## ASSESSMENT REPORT

### Science and Engineering Building, University of New South Wales SSD 7518 MOD 1

**Figure 3:** Proposed Ground Floor storage area (Source - SSD 7518 MOD 1 Modification Request)

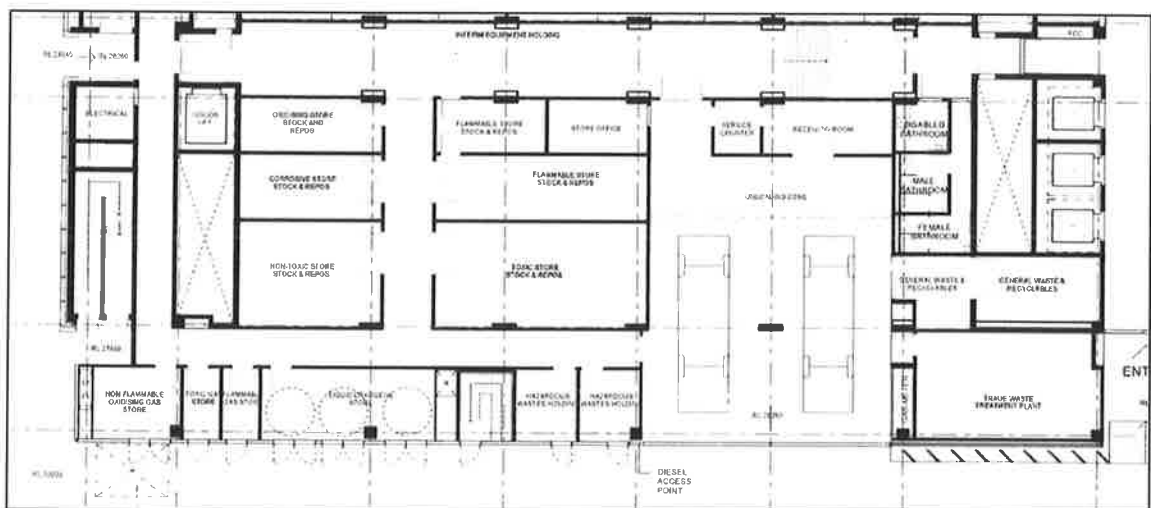
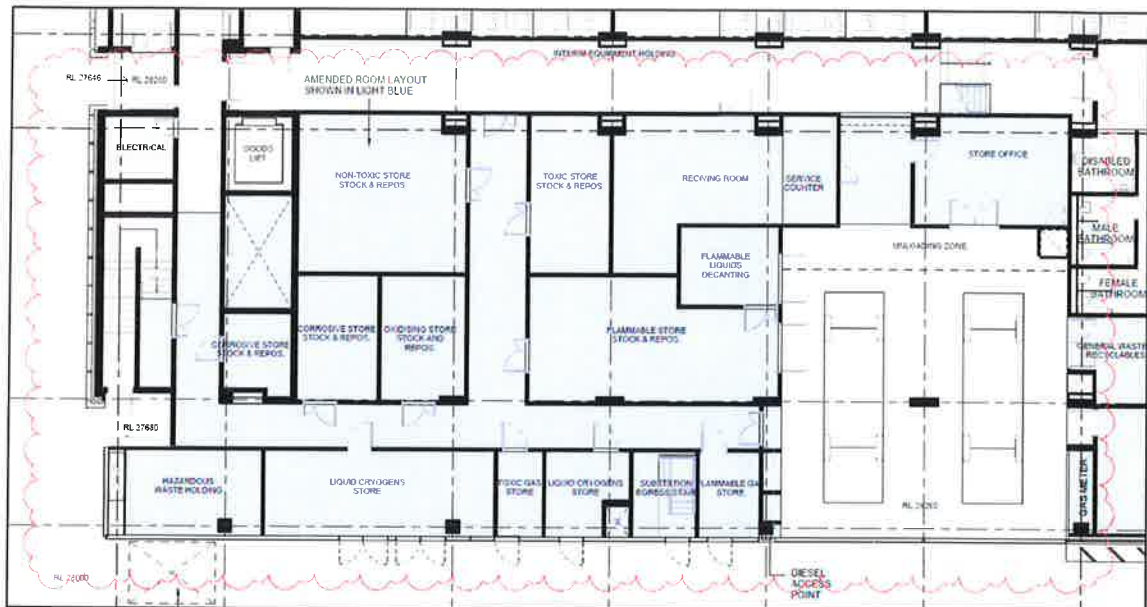
- a revised ground floor storage layout to better suit the needs of the SEB. The Applicant confirmed that the proposed modifications do not result in additional storage capacity for hazardous materials. The approved and proposed modification to the ground floor storage area is identified in **Figures 2 and 3** respectively.

- the revised ground floor storage layout would not increase the quantities of the hazardous materials stored within the building and existing conditions of approval would appropriately manage the storage and handling of hazardous materials

**Figure 4:** Proposed mezzanine level (Source - SSD 7518 MOD 1 Modification Request)

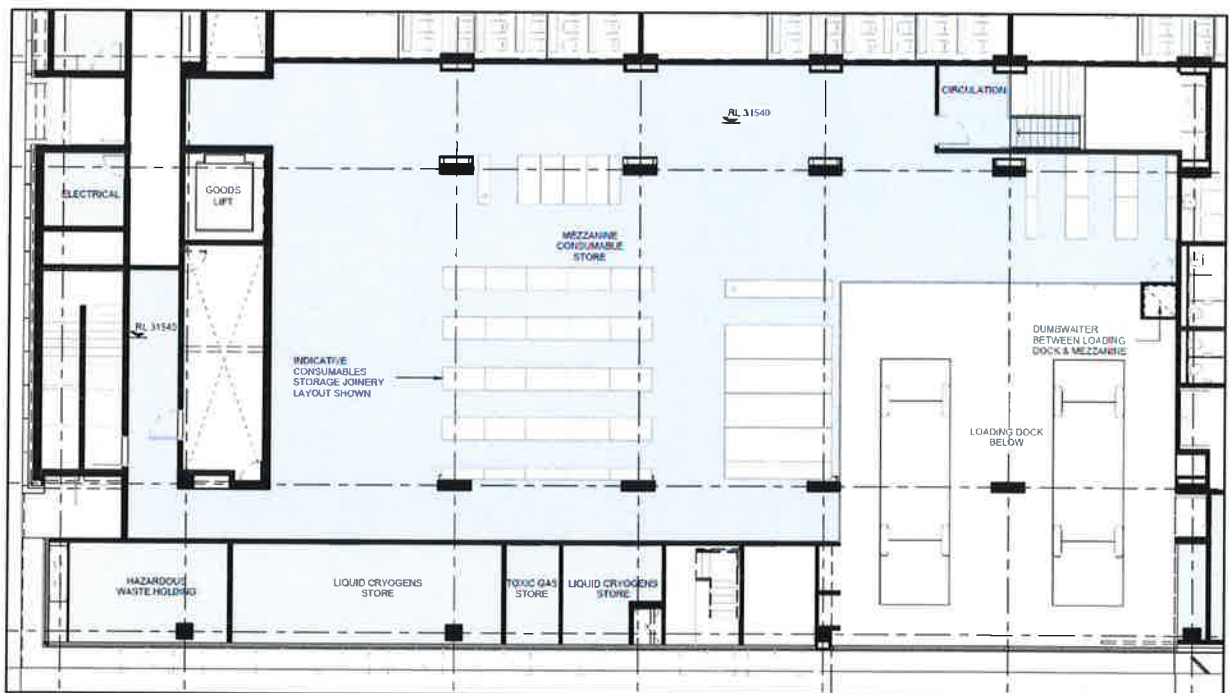
- the addition of a mezzanine level which is to be accommodated within the approved SEB envelope. The Applicant proposes to achieve this through splitting part of the ground floor (identified in **Figure 3**) into two levels. As such, this section of the ground floor level (identified in **Figure 3**) will reduce in height from 6.84 m to 3.28 m, with a mezzanine level located above with a height of 3.56 m (refer to **Figure 4** and **5**). The proposed mezzanine level will not result in any changes to the façade of the SEB, however it will result in an additional 473 sqm of gross floor area (GFA). The mezzanine level would be used for storage of consumables such as paper, glassware and basic laboratory equipment.

- the addition of the mezzanine level would not physically change the appearance of the SEB
- the additional GFA resulting from the mezzanine level is minor and it would not result in additional staff or student numbers or affect parking requirements

- the proposed floor to ceiling heights of 3.28 m and 3.56 m for the ground floor and mezzanine storage areas, respectively, are considered appropriate for storage rooms

- the additional storage area within the new mezzanine level would only be used for consumables such as paper, glassware, stationary and other laboratory consumables and would not be used for storing hazardous materials

**Figure 6:** Proposed northern elevation view of the lift extension and mechanical exhaust to the podium (Source - SSD 7518 MOD 1 Modification Request)

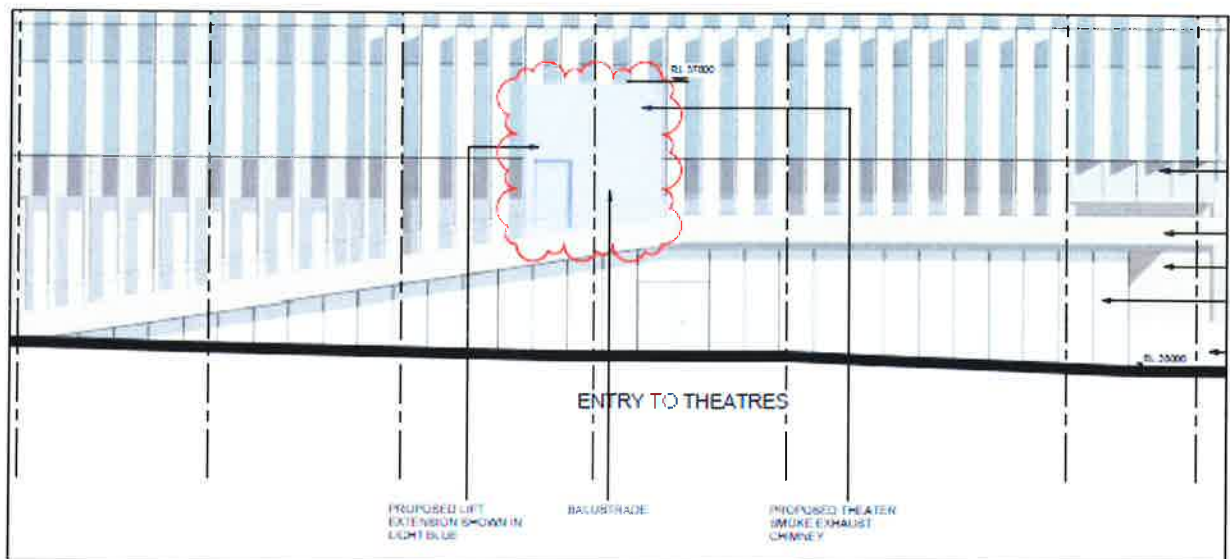
- podium modifications to extend the lift core, the addition of a mechanical exhaust and extend the top of the podium. The approved lift core services the IO Myers Theatre, Studio 1a and the foyer areas, and does not extend to the podium surface level. As such, it is proposed to extend the lift core through the podium slab to allow for an alternate method of access to the podium. The proposed mechanical exhaust will extract smoke exhaust from the theatre space below (refer to **Figure 6**). The extended lift core and exhaust are proposed in the same location to minimise visual impact and allow for an integrated external cladding solution. The lift core extension and mechanical exhaust will result in a structure which is 5.05 m above the previously approved level of the podium. It is also proposed to extend the southern end of the flat portion of the podium, in place of the bleacher style seating in this location, and provide associated balustrading to create a larger lift lobby area (refer to **Figure 7**).

- the modifications to the podium are minor and would not be visible when viewed from surrounding external public areas
- the addition of the podium lift access and extension of the flat surface of the podium would improve access to the podium, which is identified as being a major focal point within the future Alumni Park

- potential impacts associated with the proposed mechanical exhaust would be appropriately mitigated and managed by existing conditions.
